STAFF RECOMMENDS THAT the Planning Commission recommend approval to the City Council of **UP08-0029, SD08-0007, PD09-0001** subject to the attached Resolution.

A RESOLUTION OF THE PLANNING COMMISSION OF THE CITY OF MILPITAS, CALIFORNIA RECOMMENDING THE MILPITAS CITY COUNCIL APPROVE SITE DEVELOPMENT AMENDMENT SD08-0007, CONDITIONAL USE PERMIT UP08-0029, AND PLANNED UNIT DEVELOPMENT PD09-0001 FOR A PROPOSED CHURCH LOCATED AT 1230 PIEDMONT ROAD

**CONDITIONAL USE PERMIT UP08-0029, SITE DEVELOPMENT PERMIT SD08-0007,
PLANNED UNIT DEVELOPMENT PERMIT PD09-0001**

A request for approval of a Conditional Use Permit, Site Development Permit and Planned Unit Development Permit to allow a 7,670 square foot church and on-site monument sign.

**SITE PLAN
ROOF PLAN
PARKING ANALYSIS
MONUMENT SIGN DETAILS**

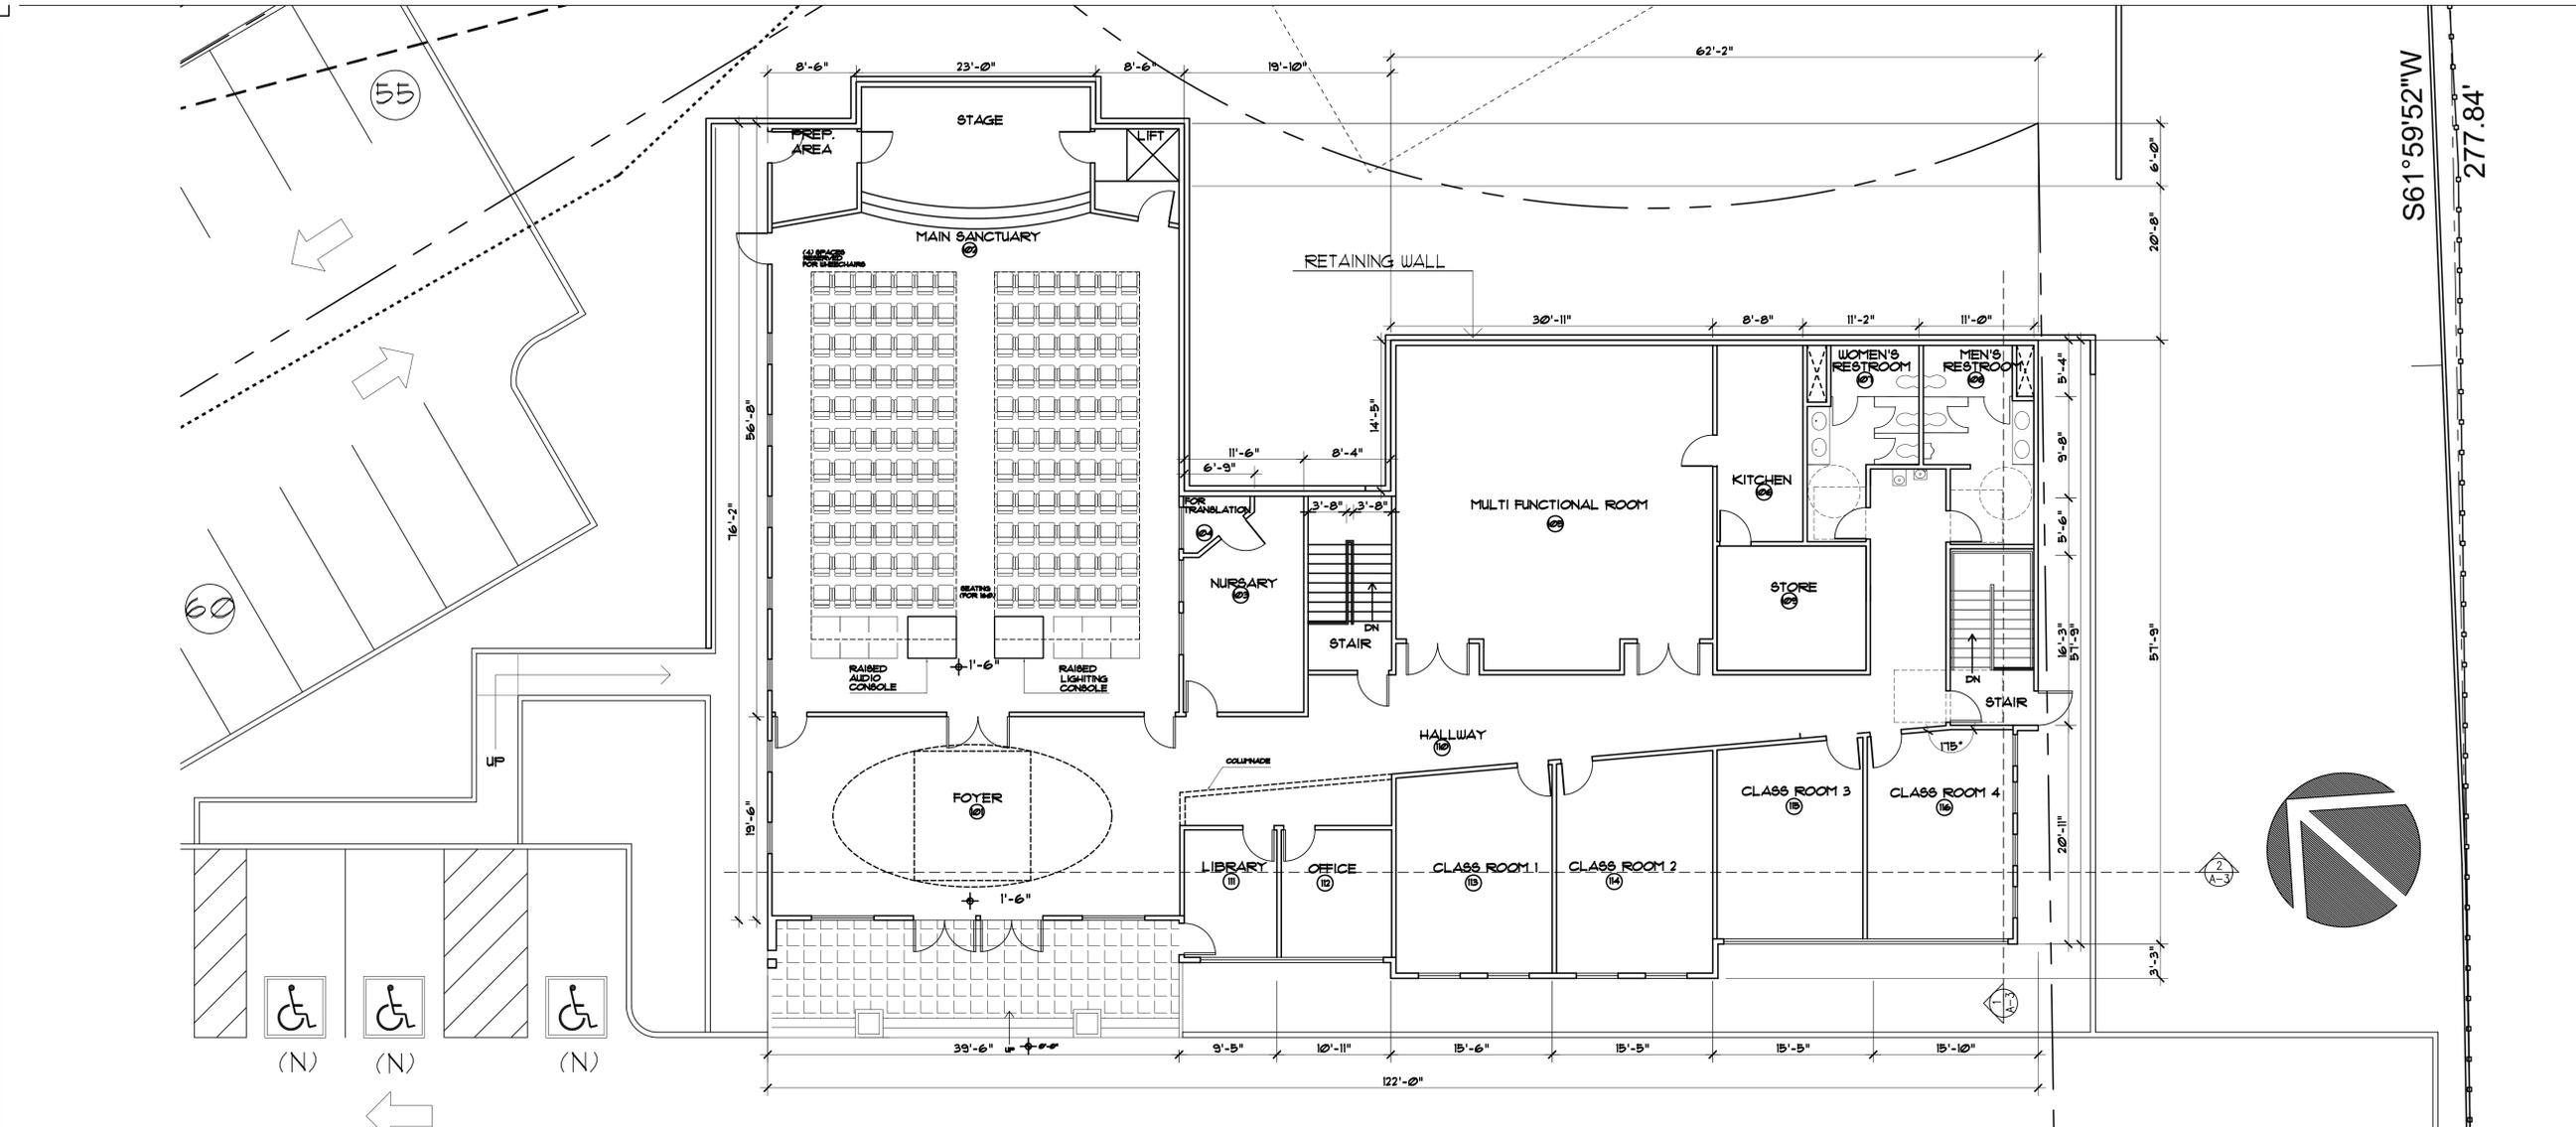
9. LANDSCAPE: At least two landscape islands shall be added to the northern row of the parking lot. A revised landscape plan shall be submitted and approved by the Planning Division prior to approval of building permit approval.
